SUBJECT: Forwards responses to NRC questions re 860402 application for amend to License DPR-67, revising Tech Spec limits on liner heat rate.

Re: St. Lucie Unit 1
Docket No. 50-335
Linear Heat Rate

RESPONSES TO THE NRC QUESTIONS
ON THE
ST. LUCIE UNIT 1 CYCLE 7, 11% SGTP
PROPOSED LINEAR HEAT RATE LICENSE AMENDMENT

a) Isolation of Steam Generator Flow

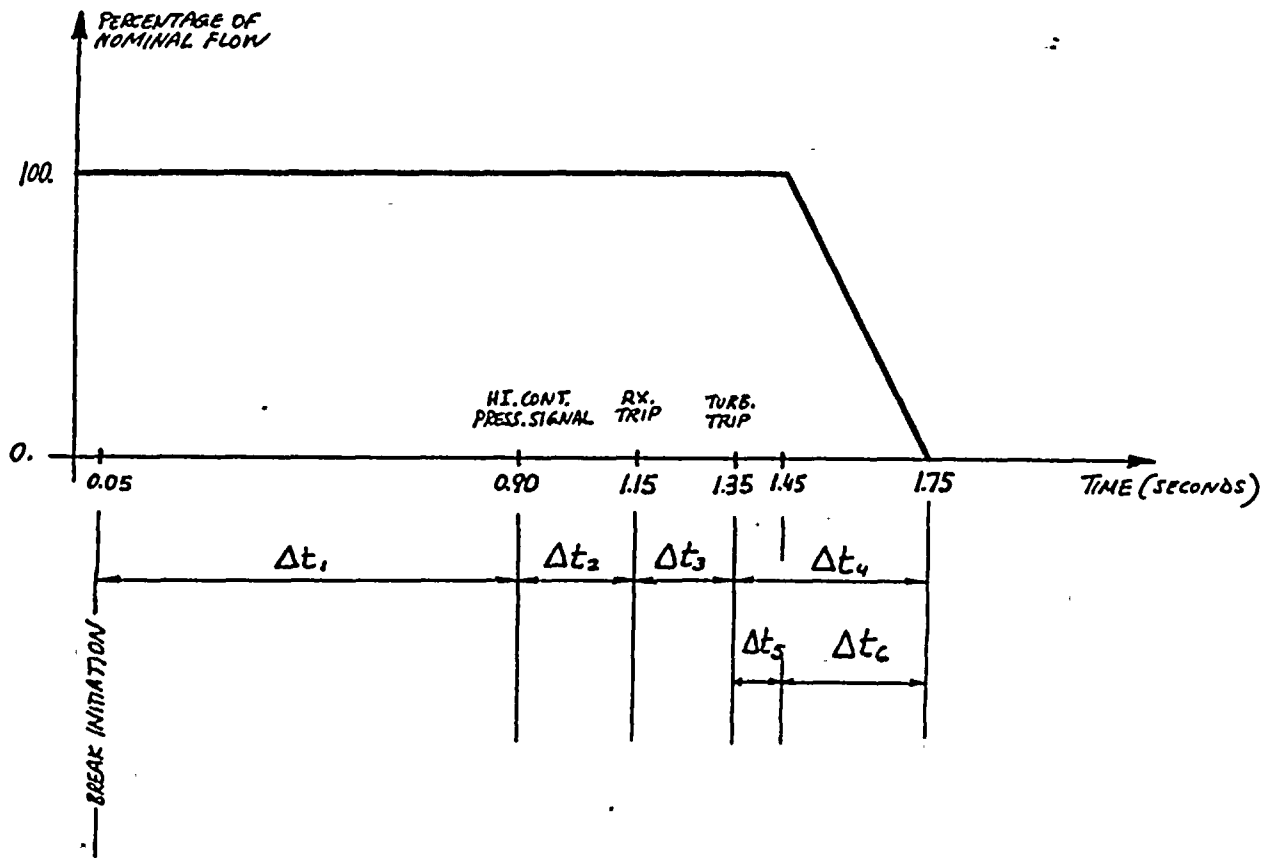
Question #4: Provide additional justification for the change in the modeling of the operation of the secondary feedwater and steam valves which allows secondary steam flow and feedwater flow after the break initiation rather than instantaneous isolation of the secondary system.

Answer: For the LOCA scenario assumed in the analysis, the steam and feedwater flows are isolated through the following logic. Immediately after break opening, a high containment pressure signal is generated. This signal produces a reactor trip signal which in turn causes a turbine trip which isolates the steam flow. The Main Steam Isolation Valves (MSIVs) are not actuated by the high containment pressure signal at St. Lucie 1. The feedwater isolation valves close on the safety injection signal. Measured closure times for these valves are in the vicinity of 60. seconds. However, flow to the steam generators will decrease more rapidly due to loss of power to the feedwater pumps and subsequent pump coastdown. Loss of off-site power is assumed concurrent with the LOCA.

The information provided below is a detailed description of the various delays and assumptions used in the isolation of the steam and feedwater flows in the LOCA analysis (see attached diagrams).

a) Isolation of Steam Generator Flow (See attached diagram)

$\Delta t_1 = 0.85$ sec. From preliminary RELAP4 blowdown analyses it can be observed that the high containment pressure setpoint of 19.7 psia is attained at 0.92 sec. A value of 0.90 sec. has been chosen here. The Δt_1 used in the analysis has been calculated as:

$$\Delta t_1 = 0.90 - 0.05 = 0.85 \text{ sec.}$$

where 0.05 sec. is the time of break initiation in the blowdown analysis.

$\Delta t_2 = 0.25$ sec. This delay corresponds to the instrumentation response time between High Containment Pressure and Reactor Trip Signals and is based on observations of the Reactor Protective System Response Times Periodic Tests.

$\Delta t_3 = 0.20$ sec. This delay corresponds to the time between initiation of reactor trip signal and initiation of turbine trip signal and is based on observations of the plant's sequence of events recorder.

$\Delta t_4 = 0.40$ sec. This delay corresponds to the time between turbine trip signal and the signal to close the governor and throttle valves and is based on observations of the plant's sequence of events recorder (typical times range from 0.40 to 0.65 seconds).

$\Delta t_5 = 0.10$ sec. This is the delay between the signal and the time the governor and throttle valves start to close. This delay is based on information provided by the turbine manufacturer.

$\Delta t_6 = 0.30$ sec. Taken as

$$\Delta t_6 = \Delta t_4 - \Delta t_5 = 0.40 - 0.10 = 0.30$$

This delay corresponds to the time it takes for the governor and throttle valves to close. Flow through these valves during closure has been assumed to follow a linear ramp.

The above assumptions on the steam isolation conservatively represent the plant behavior in the case of a large break LOCA.

b) Isolation of Feedwater Flow to the Steam Generators
(See attached diagram).

The feedwater isolation valves close on the safety injection signal. Measured closure times for these valves are in the vicinity of 60. seconds. However, flow to the steam generators will decrease more rapidly due to loss of power to the feedwater pumps and subsequent pump coastdown. Loss of off-site power is assumed concurrent with the LOCA. After discussions with plant staff it was concluded that the assumption used in the analysis of a linear coastdown of 2.0 seconds from the time of the break initiation would be reasonably conservative. Exxon estimates that this assumption on feedwater flow had little effect on the results of the transient.
